New South Wales Government
Independent Planning Commission

Donnison Street Gosford
Gosford Alive SSD 9813

Statement of Reasons for Decision

25 September 2020

Figure 2: Extract from GUDF
Section 2 Place-Based Framework and Recommendations Kibble Park

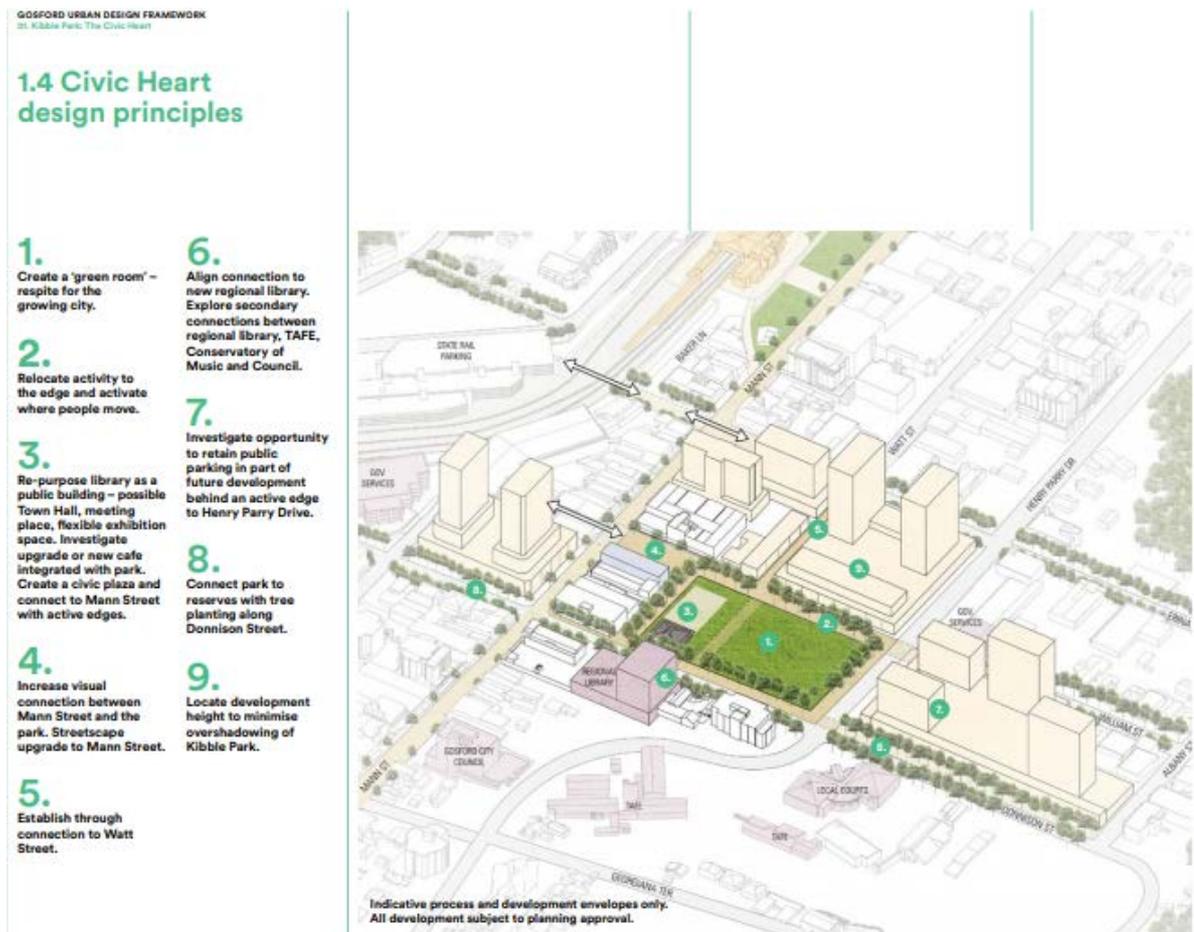
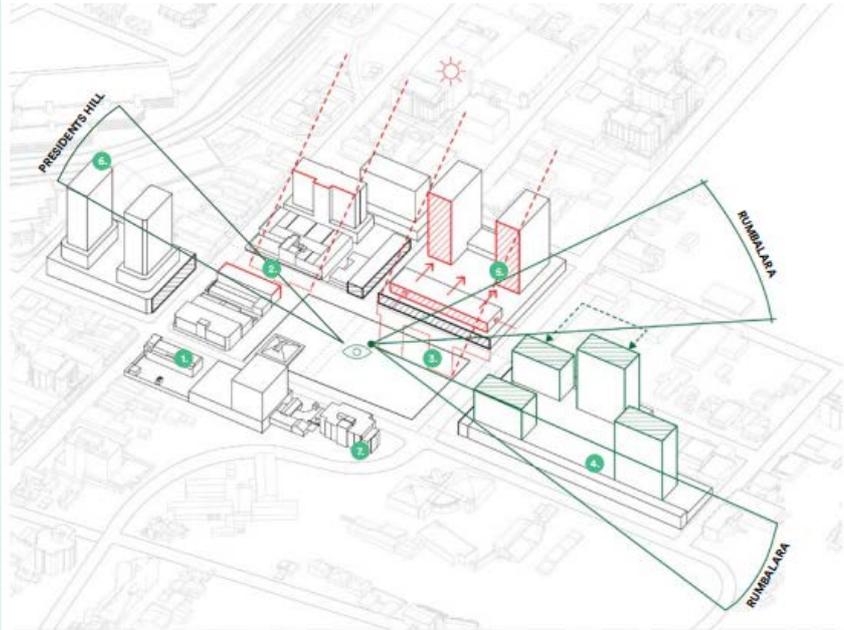
115. The Commission agrees with the comments made by the CEN, but notes that the dimension of towers facing onto Kibble Park is established in the GUDF. The important view corridors identified in the GUDP and the DCP are diagonally across to the Ridgeline, not through the centre of the Site (see **Figure 2**).

141. As proposed, and as shown in Figure 18 of the Department's AR, Towers 4 and 5 are both at the same height. The 'dome' does not provide for a graduation of heights. It is not consistent with the stepped effect shown in **Figures 2 and 3** above in the GUDP. This clearly shows two southern towers stepping up from Kibble Park and likewise, the two northern towers. No tower is shown between what is now Towers 2 and 5. The Commission concludes that Tower 4 should be stepped consistent with the height controls shown on the HOB Map in cl 4.3 of the GSEPP (see paragraphs 56 and 57 above). This is also consistent with the DCP provisions requiring a variation in tower heights, as follows:

Figure 10: Plan view – Amendments to the envelope lengths of Towers 1, 2 4 and 5 (reduction shown dashed red)

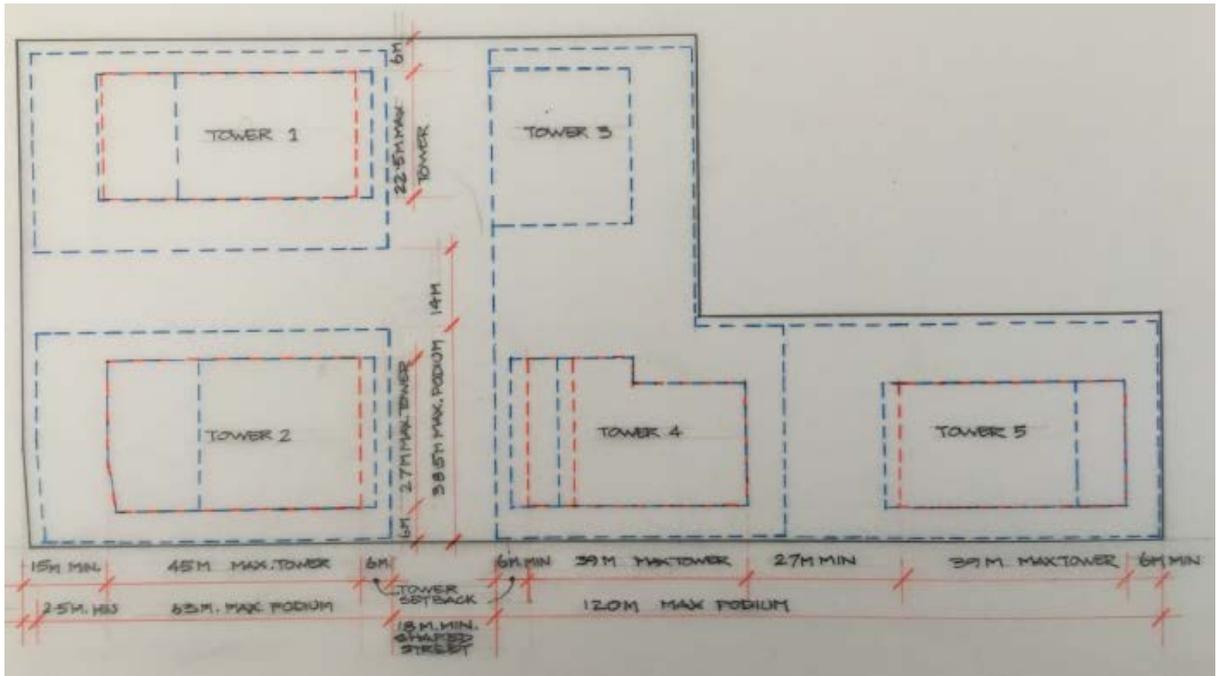
121. In order to ensure the more slender east-west orientation of Towers 1 and 2, the Commission has imposed **Modification B3a)** which requires that the concept envelope be amended to reduce both towers at the eastern end by 3m, thereby reducing the overall lengths of the envelopes from 48m to 45m. This will assist in future buildings being able to demonstrate design excellence, as discussed in Section 5.2.8.

123. Consequently, the Commission imposes **Modification B3b**) that requires Tower 4 to be reduced in length by 3m on the western side. The current stepped profile shall remain. This will identify the corridor along the north-south through site link and provide improved solar access. The future Tower should also chamfer, in the same way as Tower 3. The envelope does not show a chamfer, so this will be an addition to the Design Guidelines (discussed in Section 5.2.8 below).

124. Likewise, Tower 5 is reduced by 3m on the western side in **Modification B3c**). This will not affect the proposed step in the profile on eastern Albany Street North side.

Figure 11: Elevational view from Donnison Street
Amendment to height of Towers 1 and 4; reduction of length of Towers 1, 2, 4 and 5 and; reduction in podium on Donnison Street/Albany Street North (reduction shown dashed red)

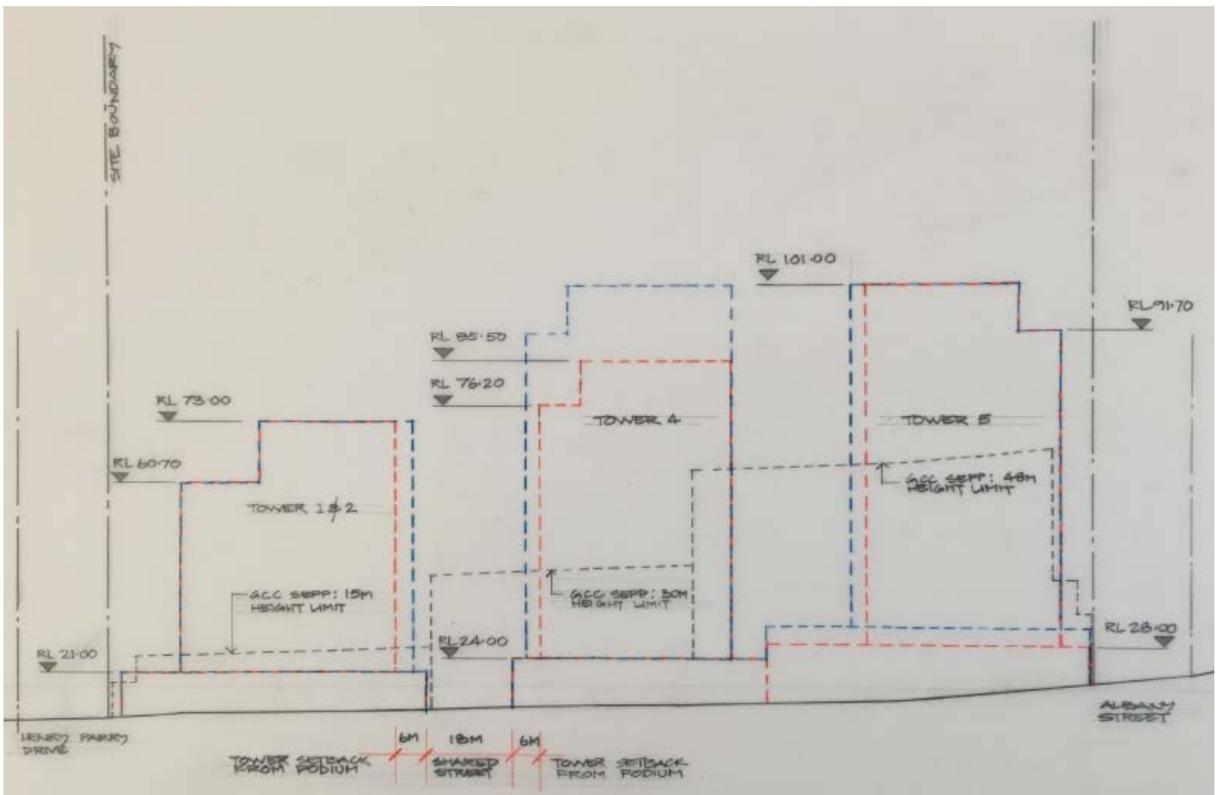
144. The Commission is of the view that the height of Tower 4 has not been adequately justified and that greater consistency with the stepped building form across the site as promoted by the GUDF would result in a more beneficial urban design outcome for the Site and Gosford CBD. The graduation of the height of buildings from east to west, from Henry Parry Drive to Albany Street North (and to Rumbalara Reserve beyond) is also consistent with the principle established in the graduated height limits shown on the HOB Map in cl 4.3 of the GSEPP (see paragraph 56 above, and **Figure 11**).

Figure 13: Possible future extension of the east-west through the Site to Albany Street North, hatched in red

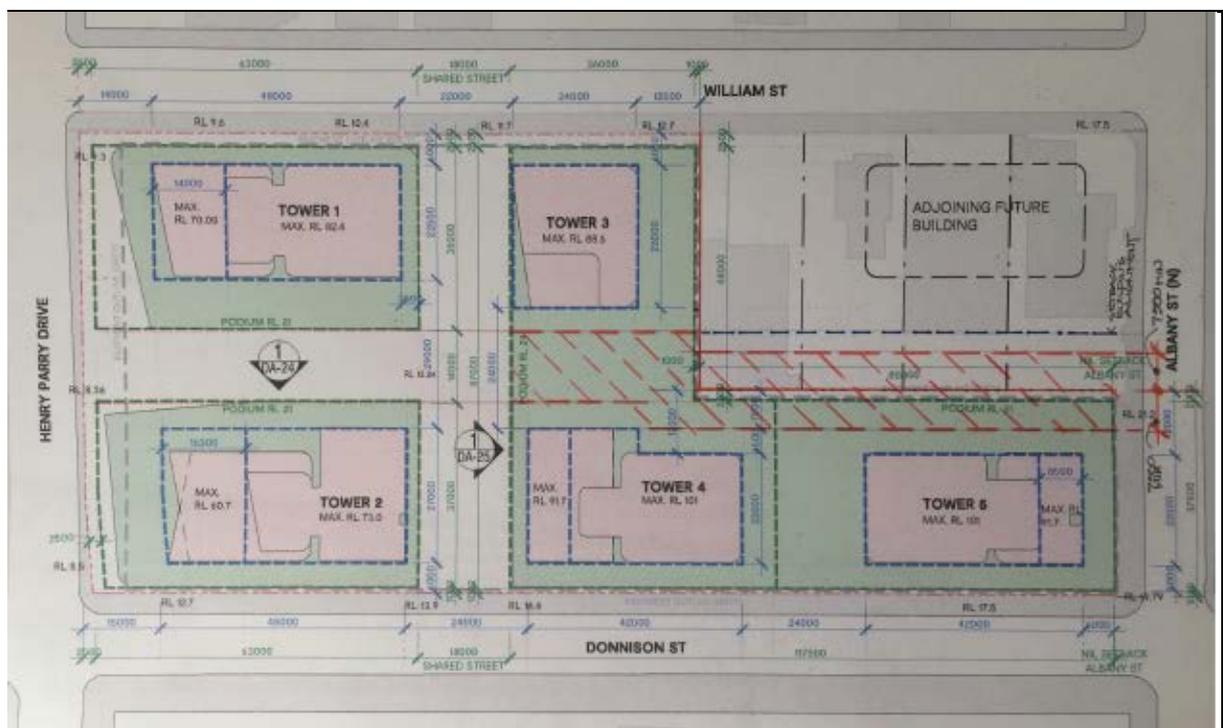
188. Any potential extension of the east-west link could be shared with the adjoining development site to the north, at 37 - 43 William Street. This Site is just over 4,000m² in area, and if consolidated would have access to potential height uplift under cl 8.4(3) of the GSEPP. It is unclear as to why the whole block was not identified as a Key Site in the DCP, to enable the integration of development on both sites. Consideration of the future link is recommended in **FEAR C5** of the Concept Approval. The proposed link is shown hatched red in **Figure 13**:
